# Memorandum

**To:** SOUTHERN NEVADA DISTRICT BOARD OF HEALTH

**Subject:** Variance Request to Operate a Public Bathing Places not in Compliance with the Nevada Administrative Code NAC 444.214.1, NAC 444.214.2, NAC 444.278, NAC 444.133 and NAC 444.134, Henderson Water Park LLC, d/b/a Cowabunga Bay Water Park, 900 Galleria Drive, Henderson, NV 89011. [Assessor's Parcel Number (APN) 161-35-402-021] For Health Permits: PR0104086, PR0104426, PR0104427, PR0104428, PR0104429, PR0104430, PR0104431, PR0104432; Shane Huish, Manager/Owner's Agent

I. Site Plan

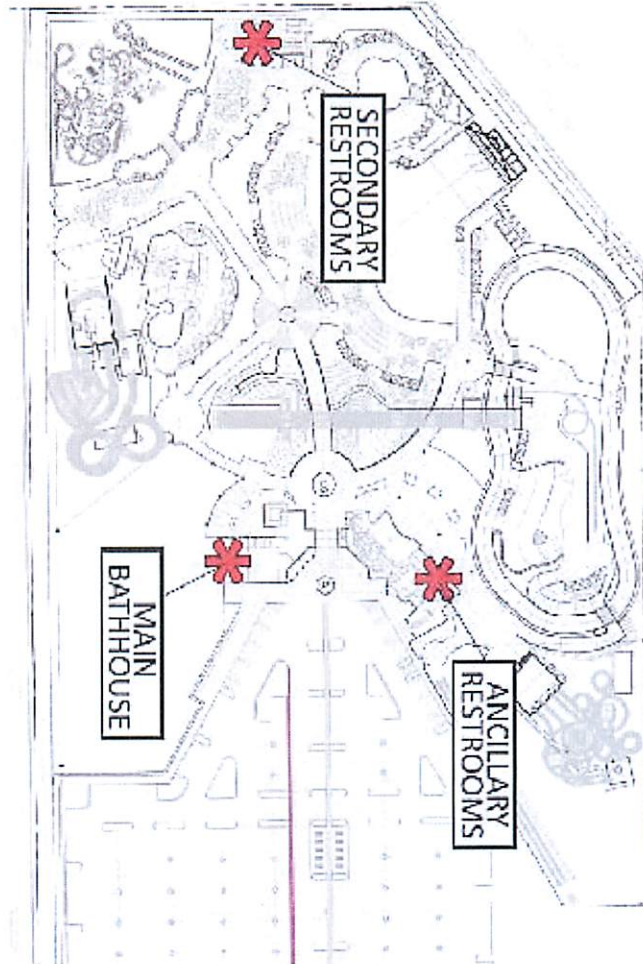
1. The bathhouse and restrooms are located throughout the waterpark complex
  - a. Main Bathhouse to provide showers for all park patrons and restrooms to serve the southeast portion of the waterpark
  - b. Secondary Restrooms to serve the west portion of the waterpark
  - c. Ancillary Restrooms to serve the northeast portion of the waterpark
2. The Lazy River Bridges located along the north property line within the waterpark complex

II. Unobstructed Decks / Bridges

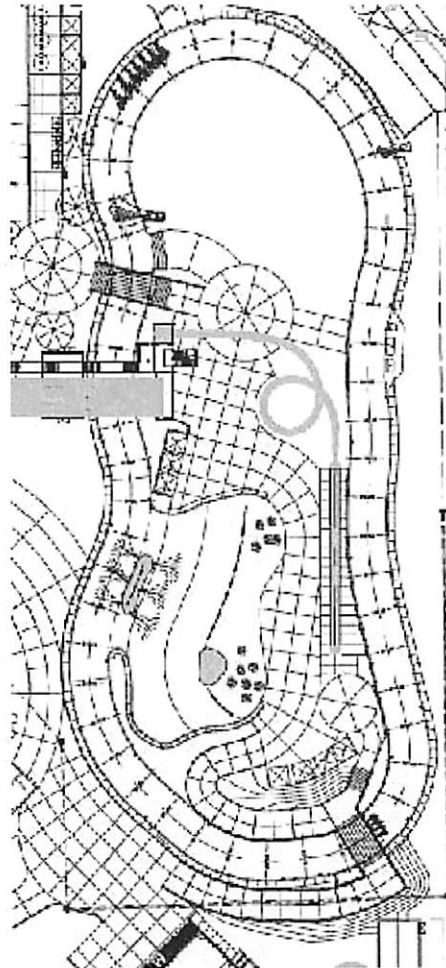
In order to access the inside area of the Lazy River and to meet the NAC height requirements from water and pool floor elevations, the bridges are designed at a slight angle from the perpendicular edge requirements of NAC 444.133 2(c). The proposed angles are not to exceed +/- 20 degrees off the perpendicular edge of the pool.

- II. **Unobstructed Deck and Bridge Requirements:** A request for a variance on the "Unobstructed Deck" and "Bridge" requirements submitted on behalf of Henderson Water Park, LLC dba Cowabunga Bay. The owner specifically

The requested variance is for the ability to eliminate the required 4 foot wide path around an obstruction on the decks to accommodate ADA requirements and to allow bridges to be slightly skewed from the 90 degrees requirements.

3. The petitioner agrees to limit the park capacity to 1500 bathers should the Health Authority determine the existing facilities are inadequate
  4. The petitioner agrees to maintain all other walkway area around the Lazy River accessible and free from obstruction
